**GENOA CHARTER TOWNSHIP
PLANNING COMMISSION
PUBLIC HEARING
MARCH 14, 2022
6:30 P.M.
AGENDA**

Attention:	Kelly Van Marter, AICP Planning Director and Assistant Township Manager
Subject:	Innovation Interchange PUD – Highway Sign Review #1

Attention:	Kelly Van Marter, AICP Planning Director and Assistant Township Manager
Subject:	A&J Cartage – Special Land Use and Site Plan Review #2
Location:	1247 Fendt Drive – east side of Fendt Drive, north of Grand Oaks Drive
Zoning:	IND Industrial District

**Re: A&J Cartage
Site Plan Review No. 2**

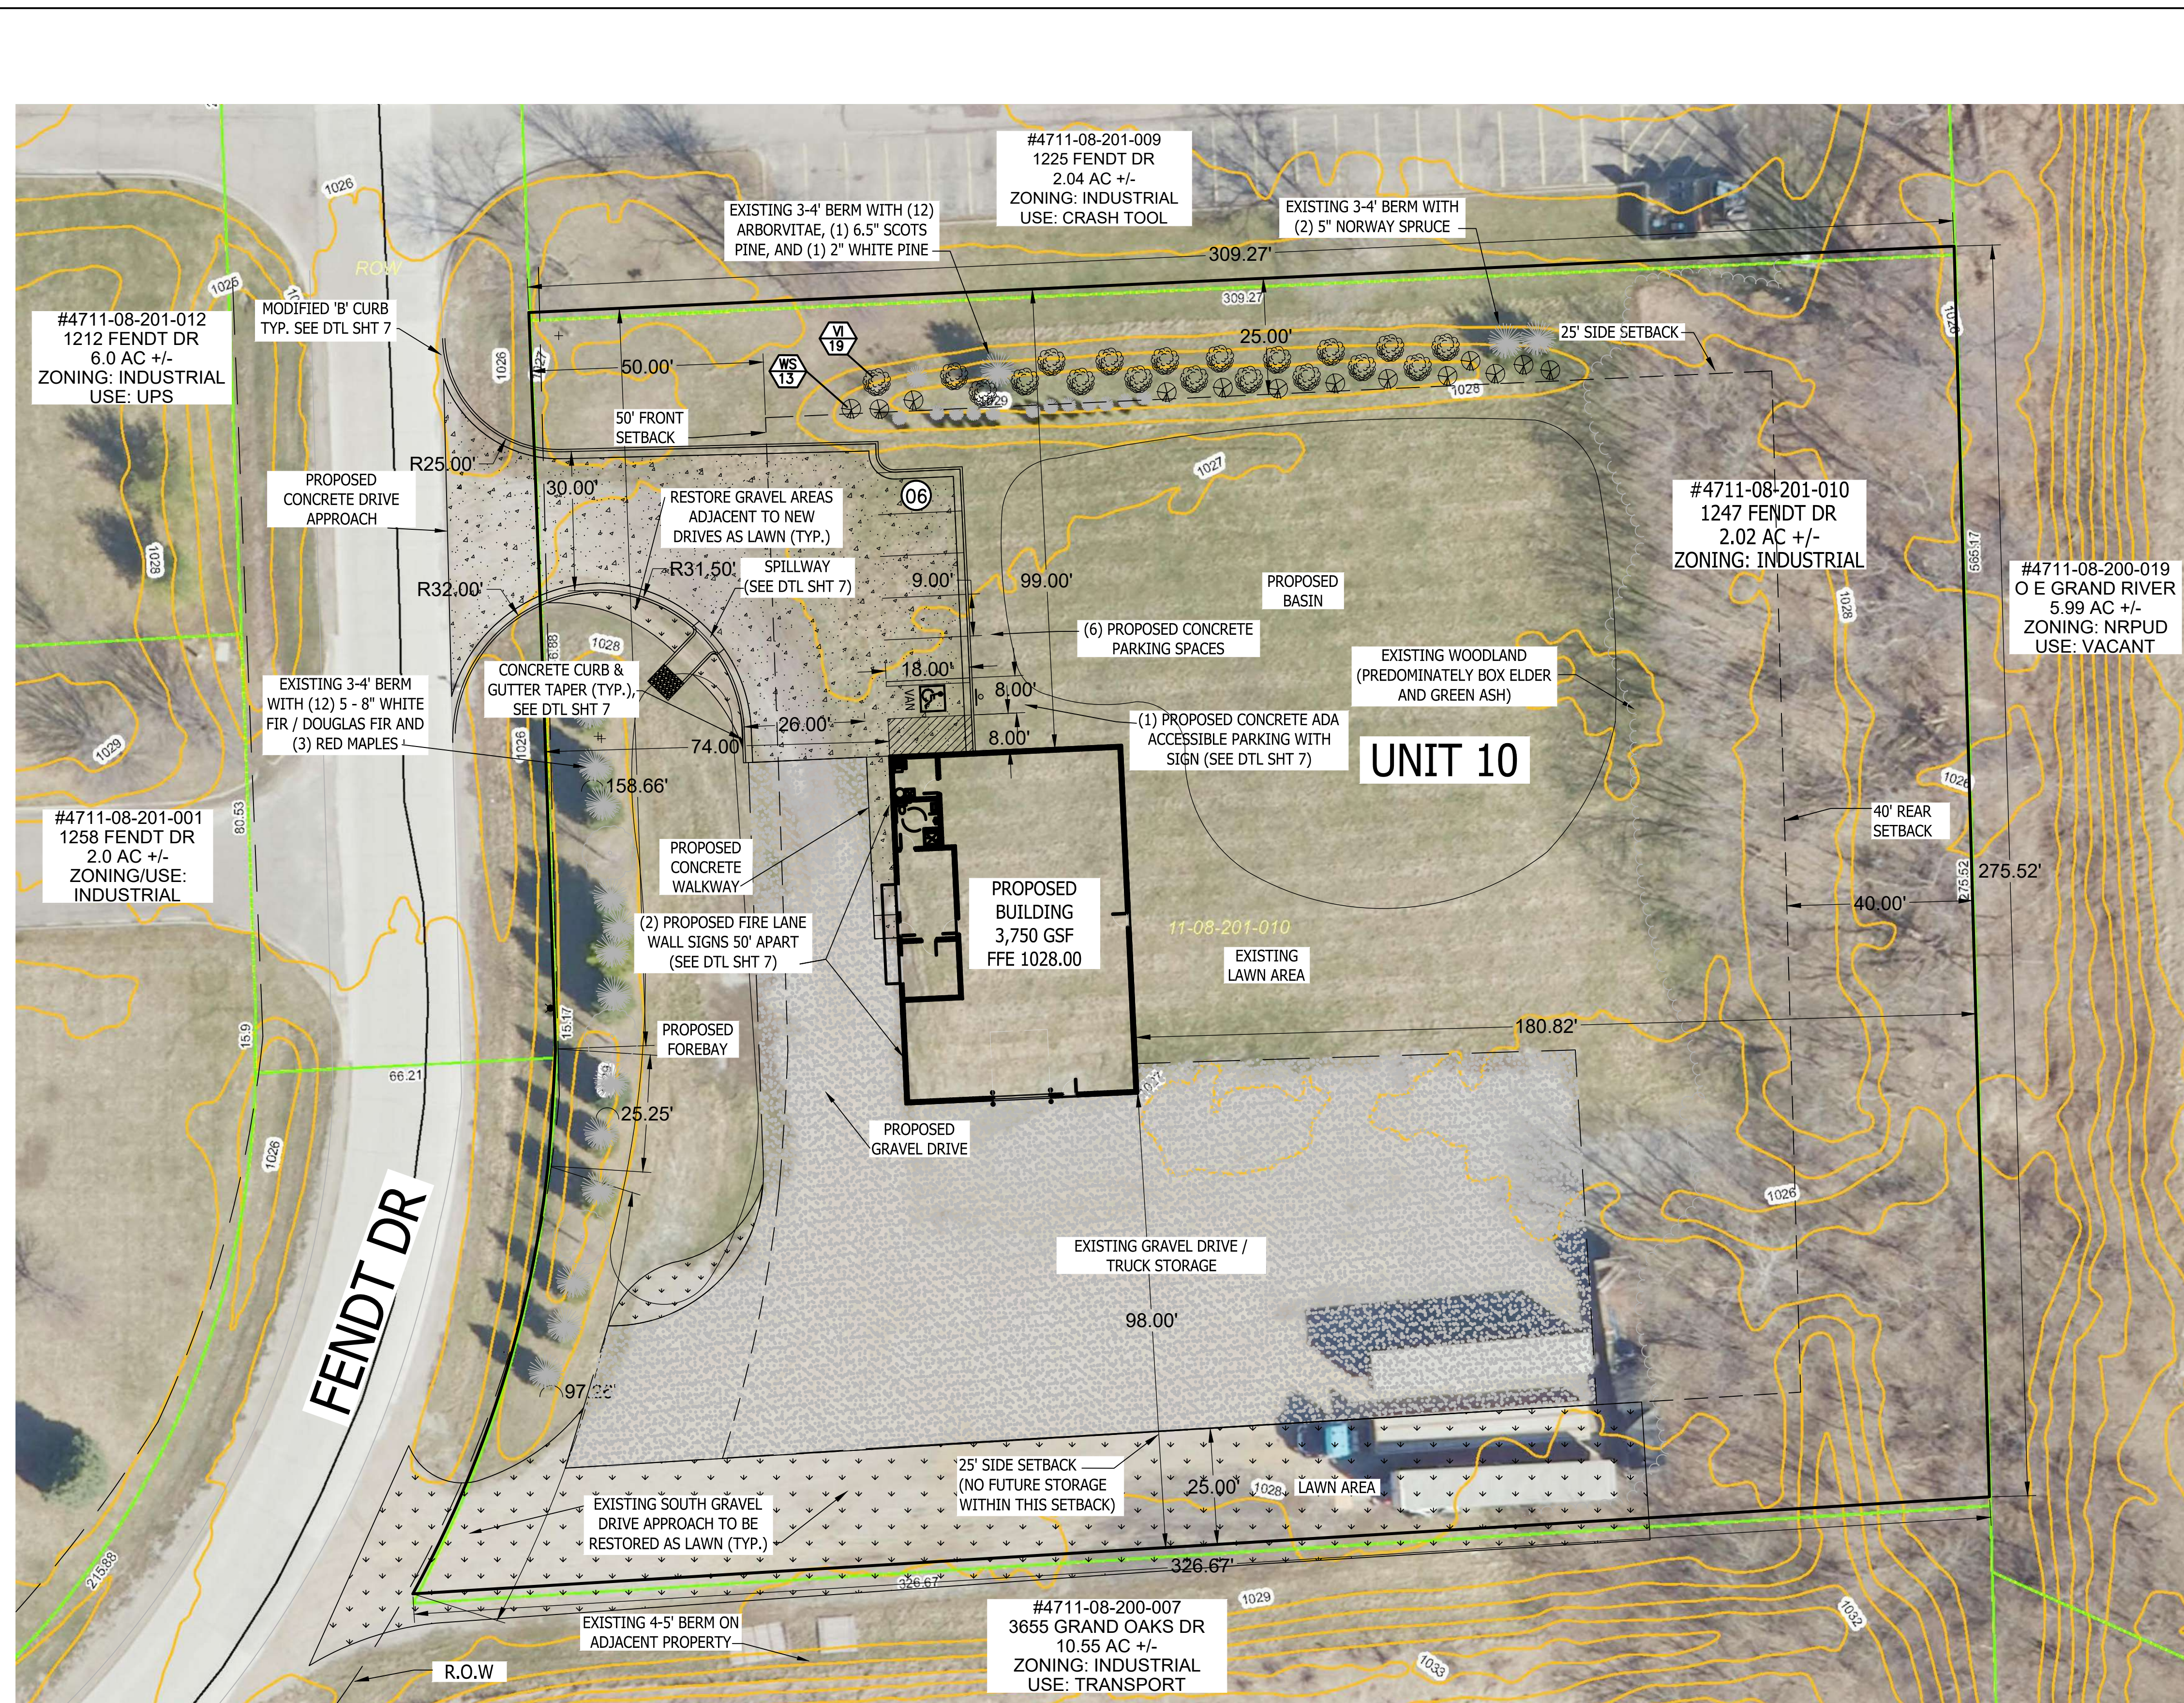
Current zoning of the subject site is IND (Industrial) and has two gravel driveway entrances, and parking for 4-6 tractor trailers. The parcel is wooded along the east property line and has planted berms along the north and west property lines. A screening berm is located along the property line on the adjacent parcel to the south. See Existing Conditions Sheet 2 for an aerial of the parcel with these features noted.

The soils and natural features throughout the site are specified on the Existing Conditions Sheet 2.
